COUNTY OF LOS ANGELES DEPARTMENT OF PUBLIC WORKS  
LAND DEVELOPMENT DIVISION  
STORM DRAIN AND HYDROLOGY SECTION

TRACT MAP NO. 52729

TENTATIVE MAP DATED 11/04/2014  
EXHIBIT MAP DATED 11/04/2014

MAJOR LAND DIVISION  
VESTING TENTATIVE TRACT NO. 52729  
LOCATED IN THE UNINCORPORATED TERRITORY OF  
THE COUNTY OF LOS ANGELES, STATE OF CALIFORNIA

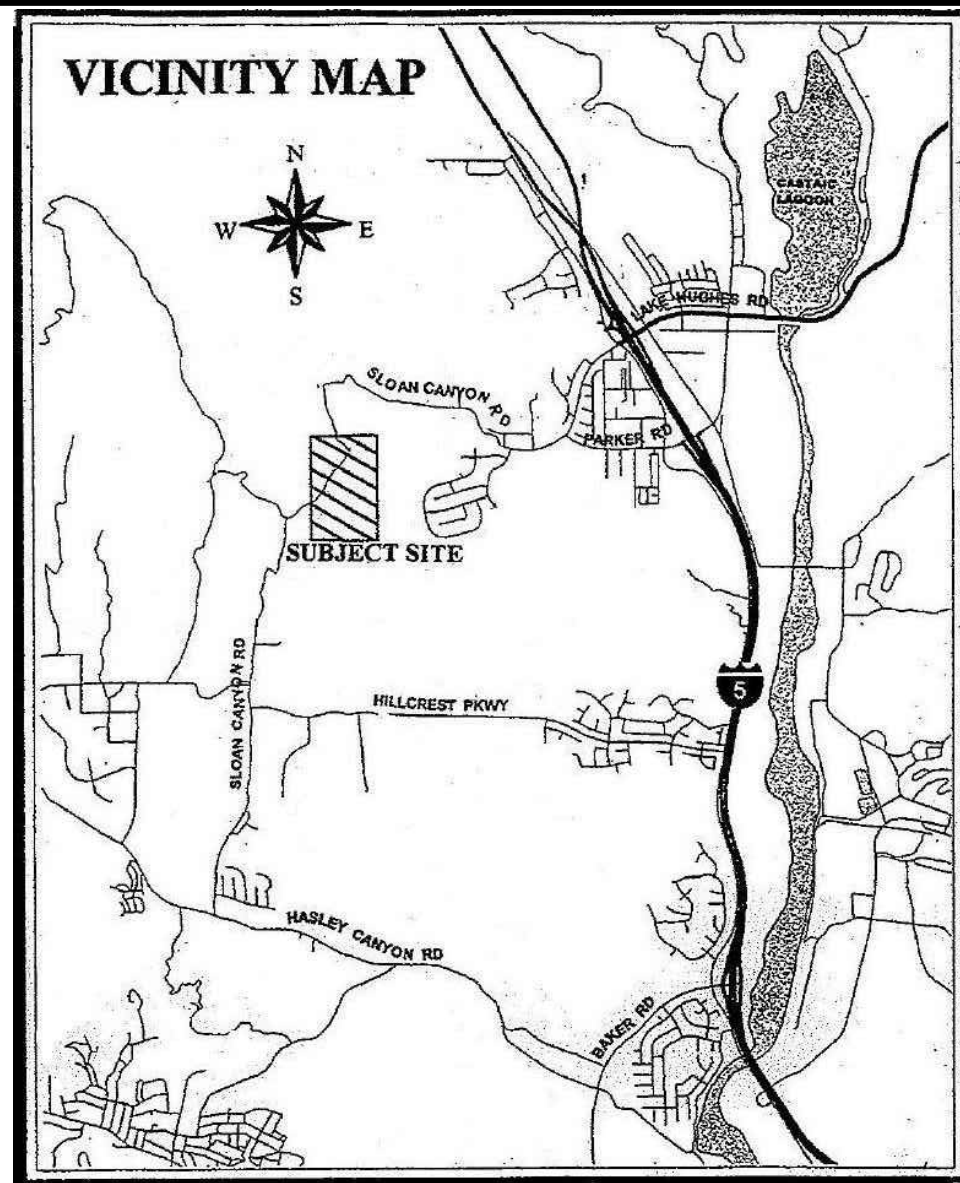
not applicable with inverted shoulders and not consistent with HDO, Healthy Design Ordinance

proposed grades are higher than the maximum grades required for local streets per Title 21, —Section 21.24.100; therefore request permission to allow up to \_\_\_\_% as part of a note on the tentative map

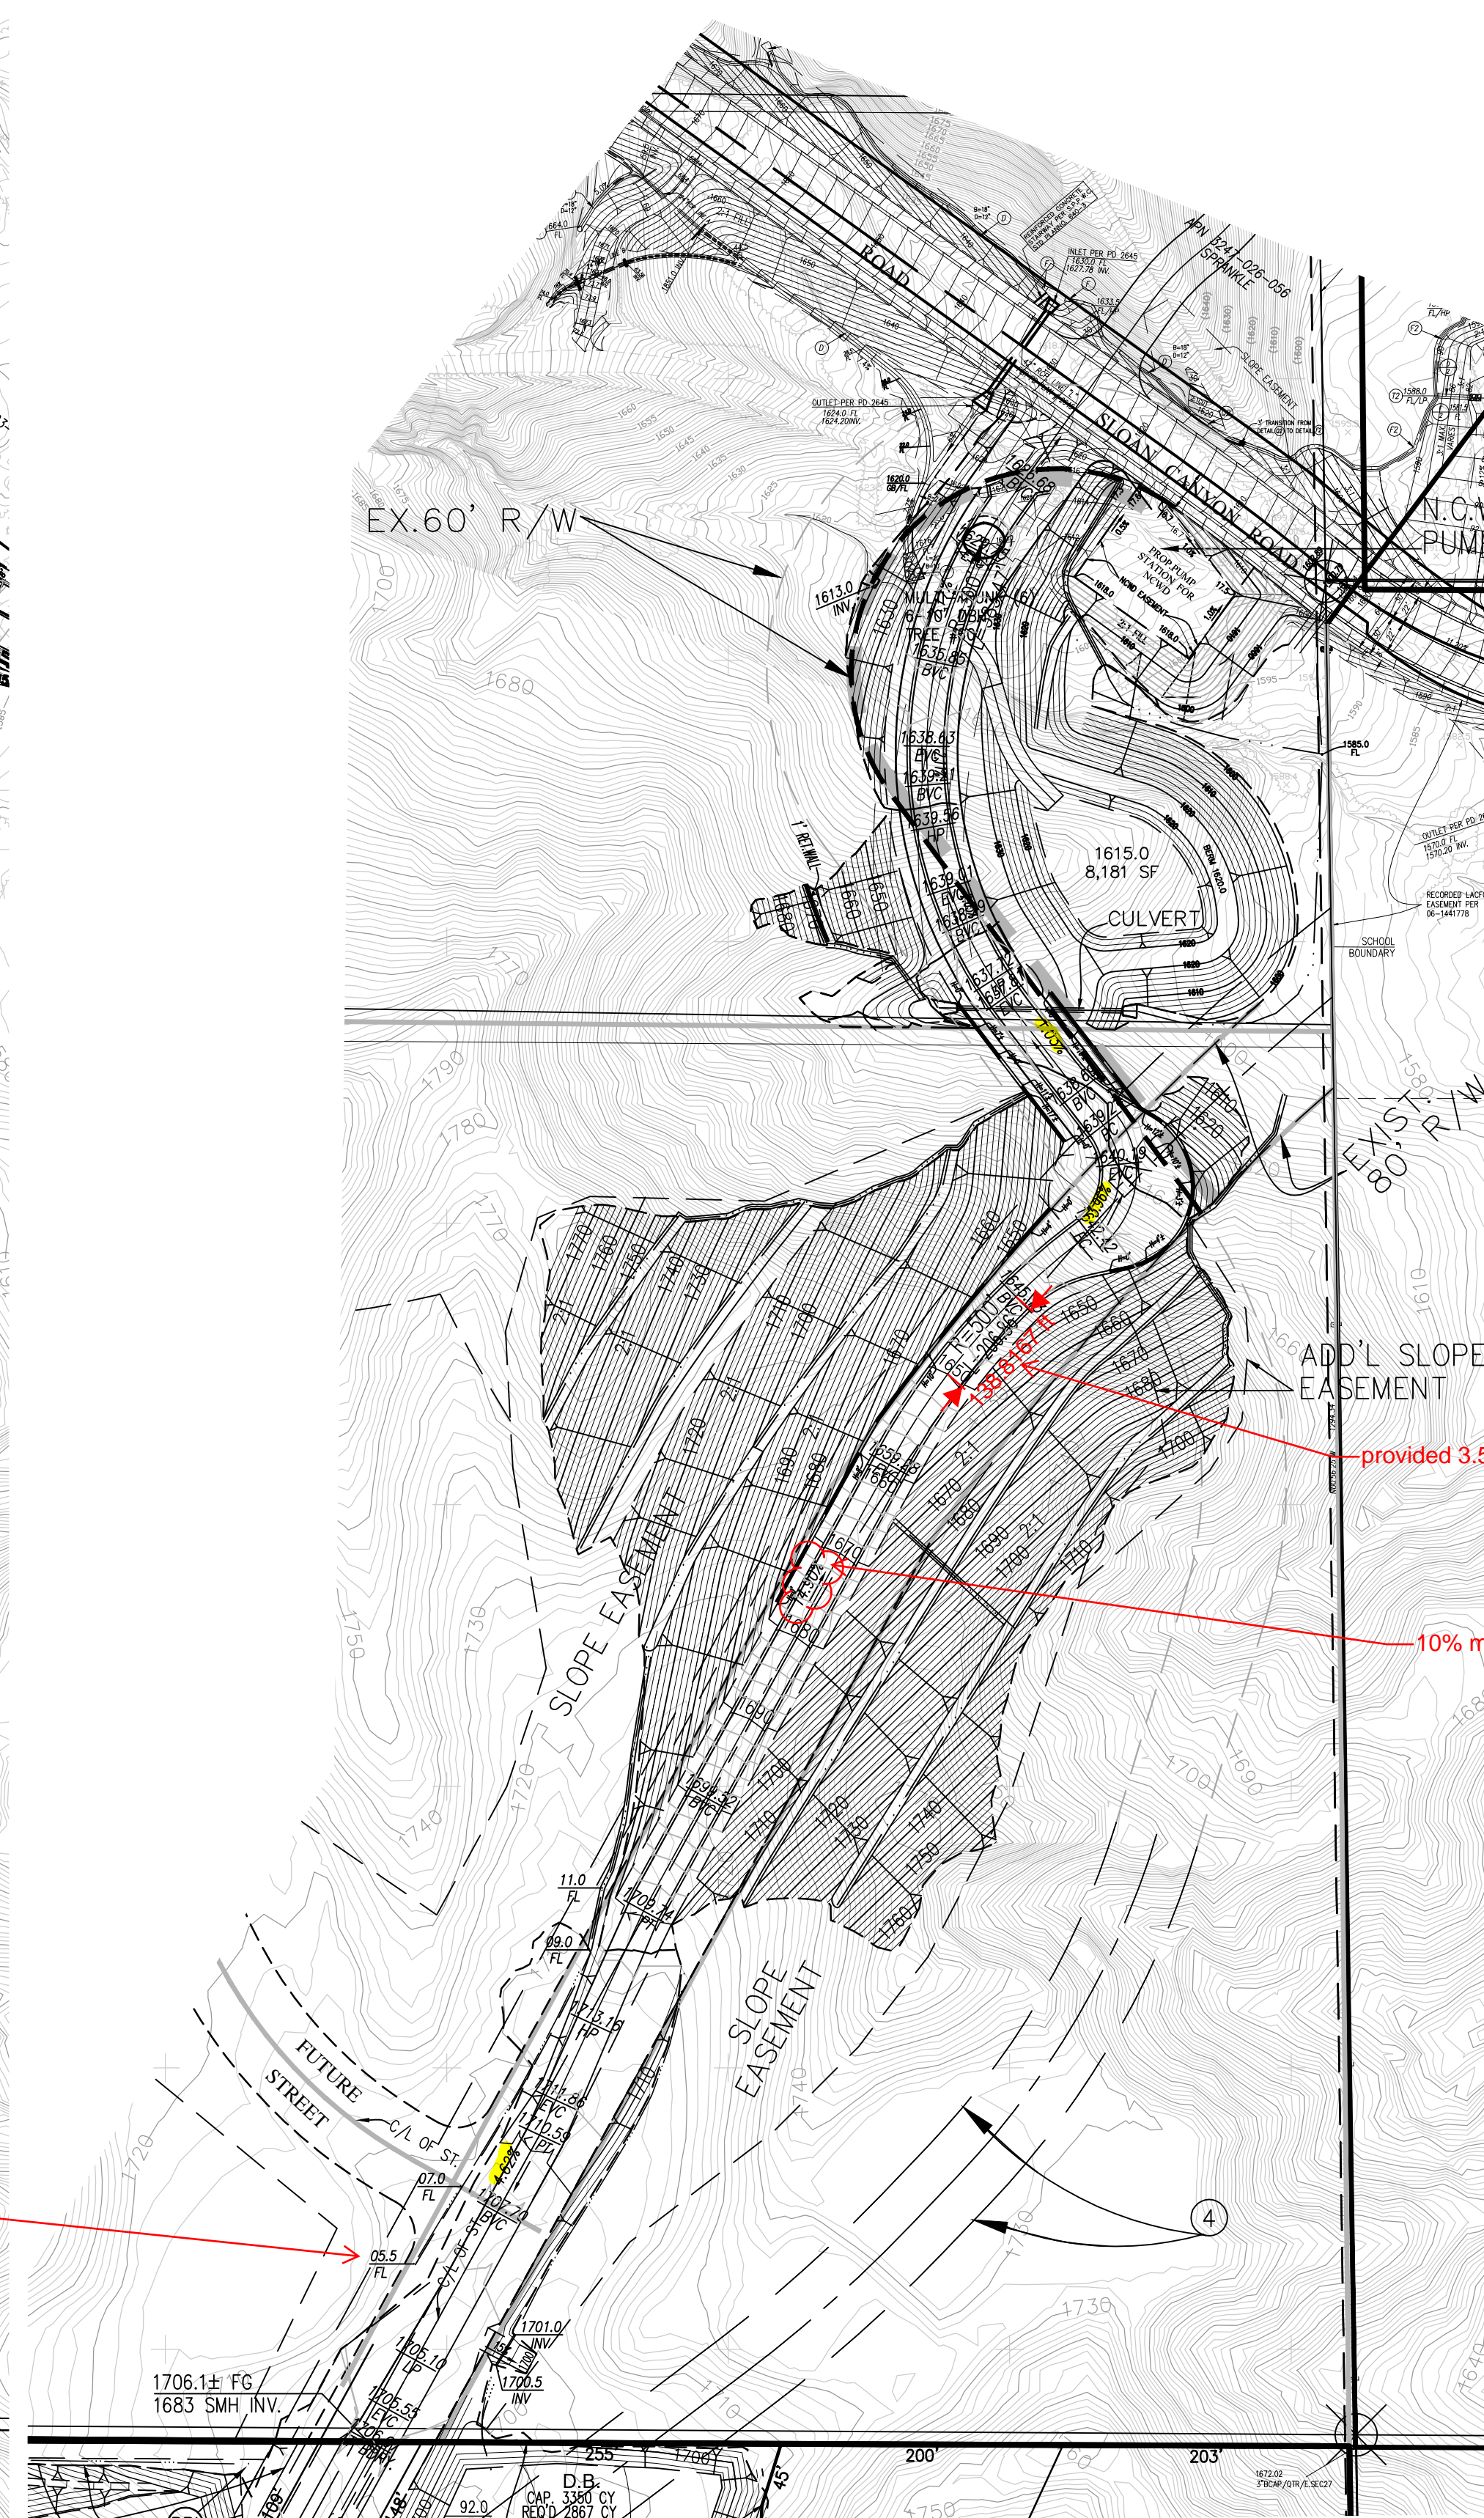
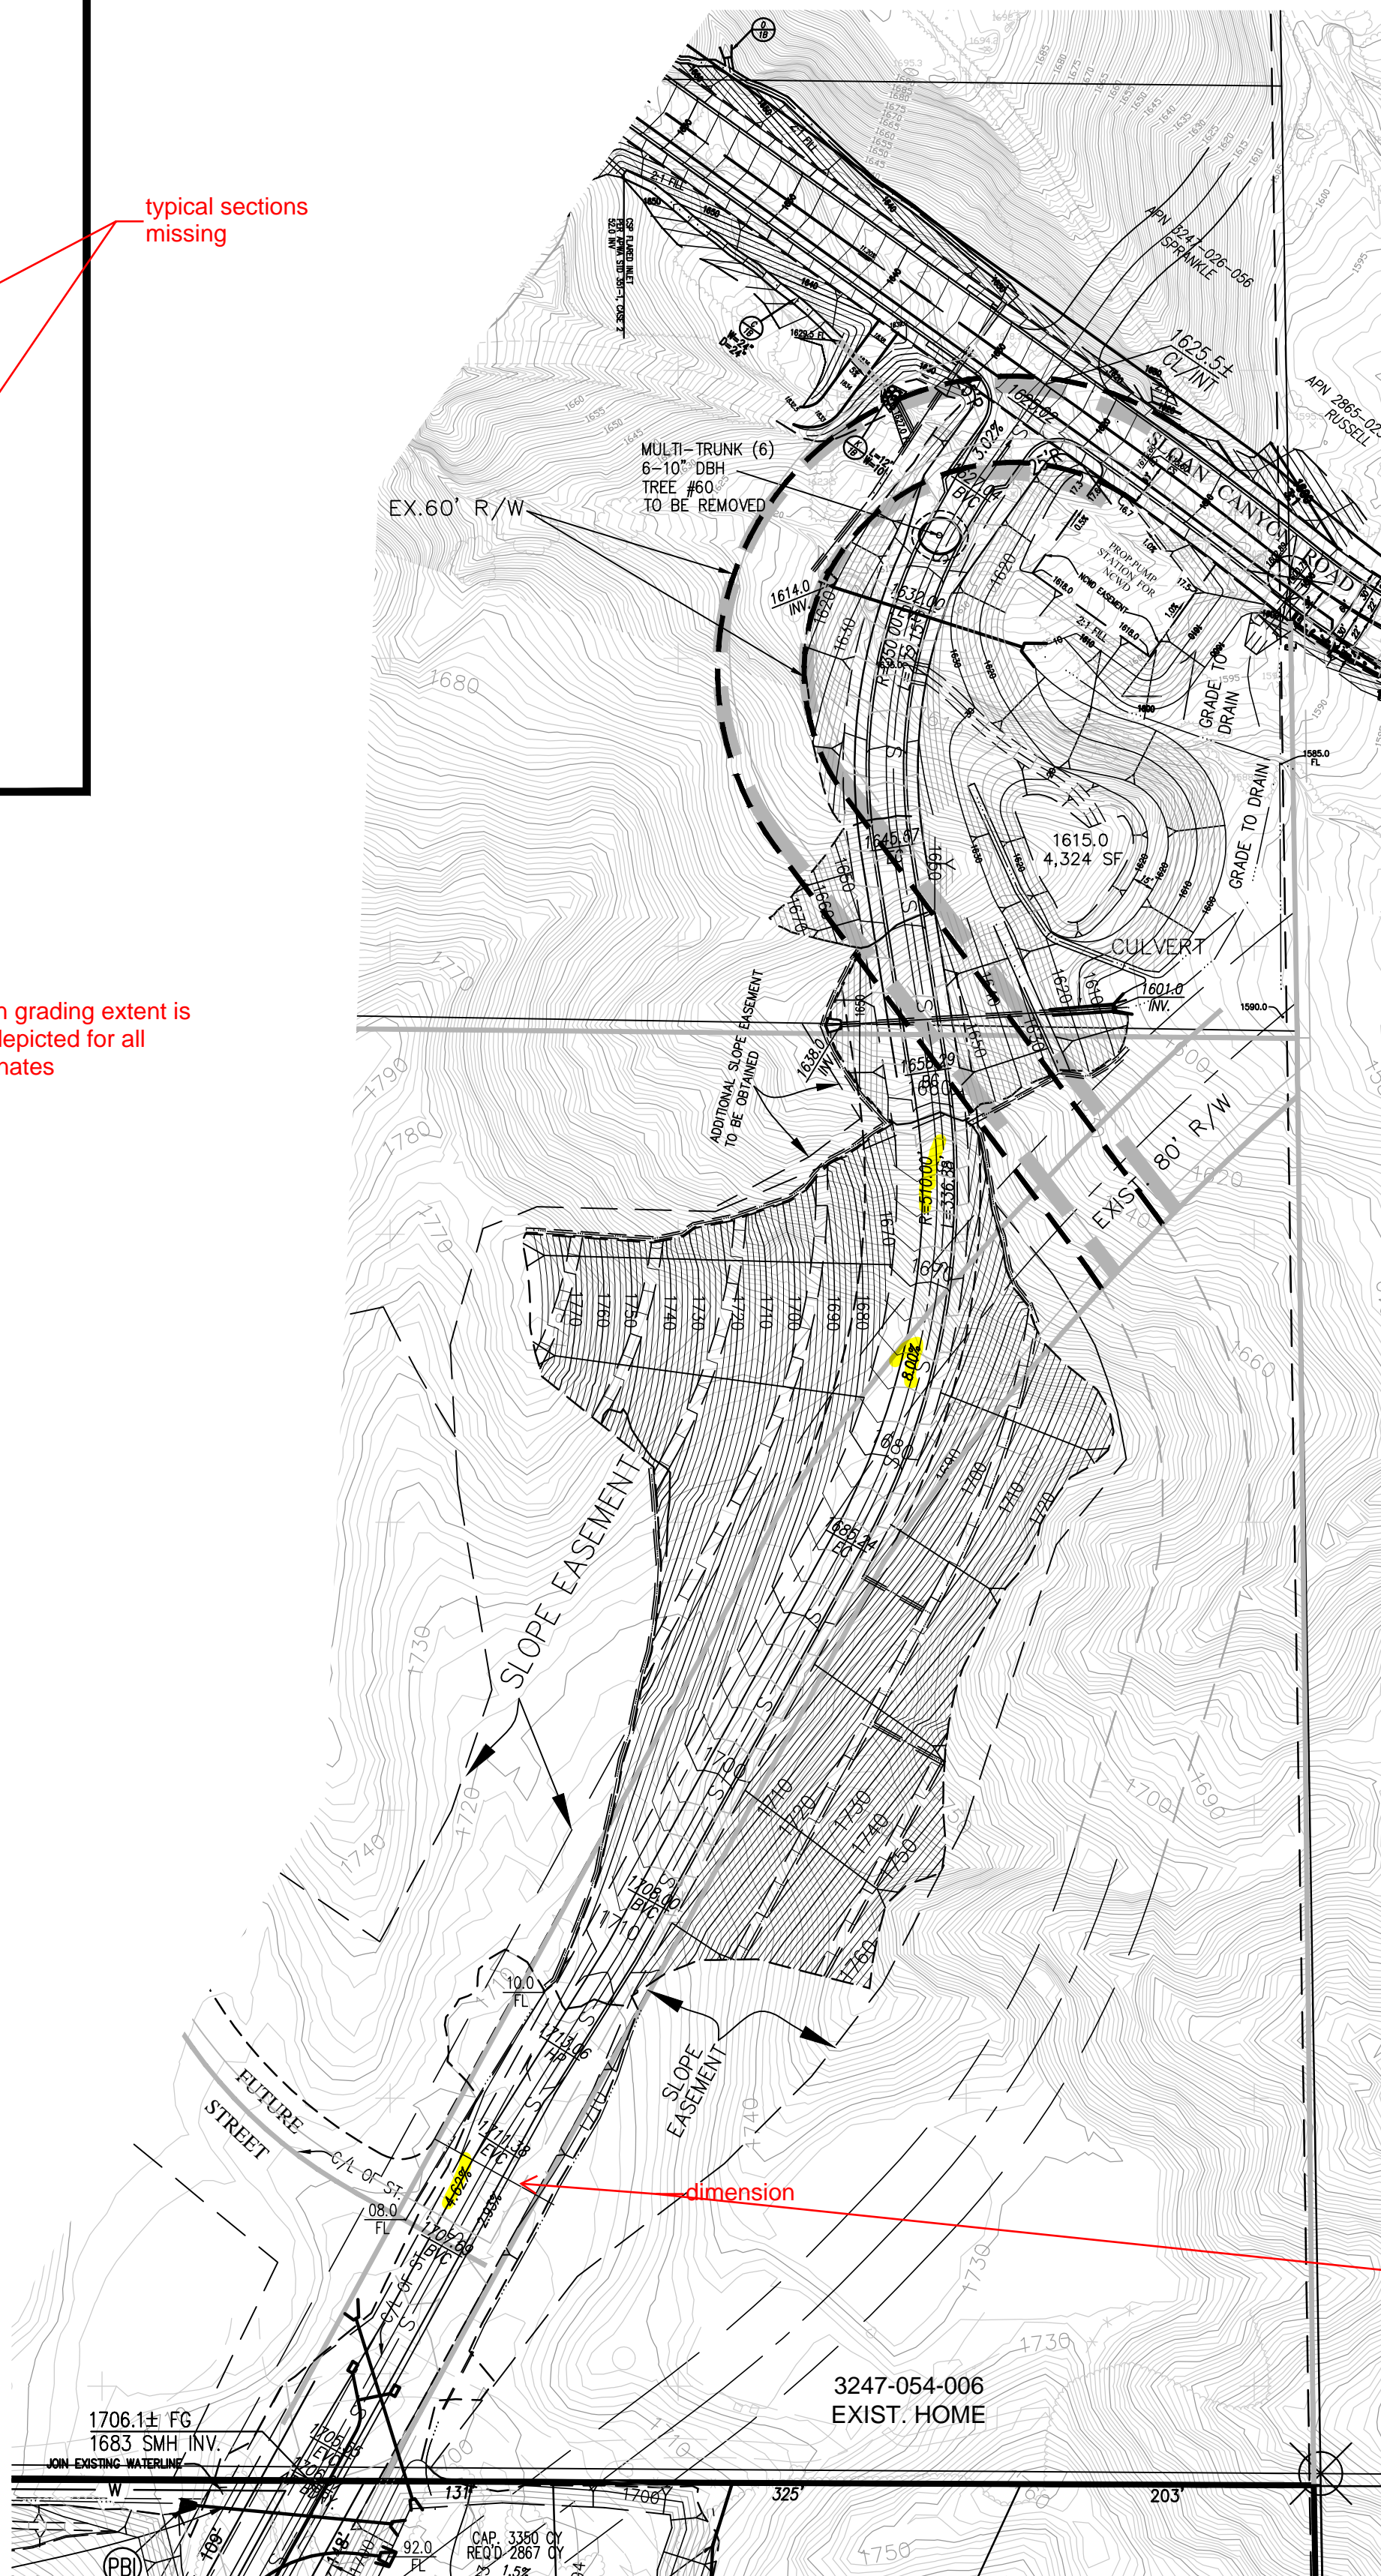
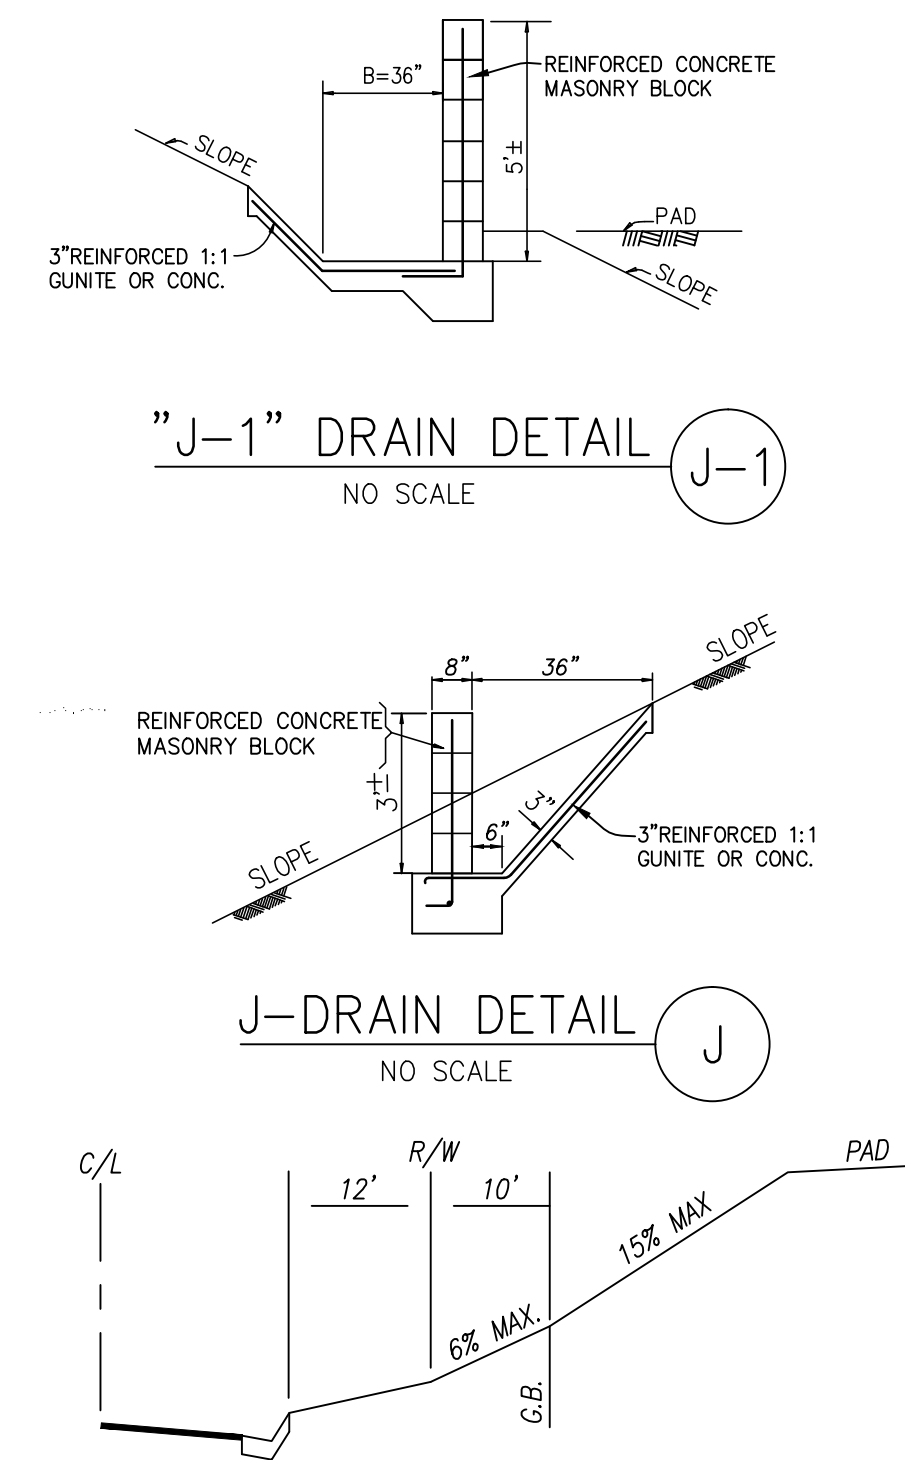
3. A revised tentative map and exhibit map. See additional road comments as shown in the attached file (2014-12-01 TTR 52729 Tentative Map checkprint.pdf) which can be found at the following ftp link:  
<ftp://dpwftp.co.la.ca.us/pub/LDD/Road/TTR%2052729r-rev4/>

show that cars will not  
scrape as they exit the  
driveway without  
proper landing, typ.  
Adjust grading  
accordingly

not applicable with inverted shoulders and not consistent with HDO, Healthy Design Ordinance

proposed grades are higher than the maximum grades required for local streets per Title 21, —Section 21.24.100; therefore request permission to allow up to \_\_\_\_% as part of a note on the tentative map
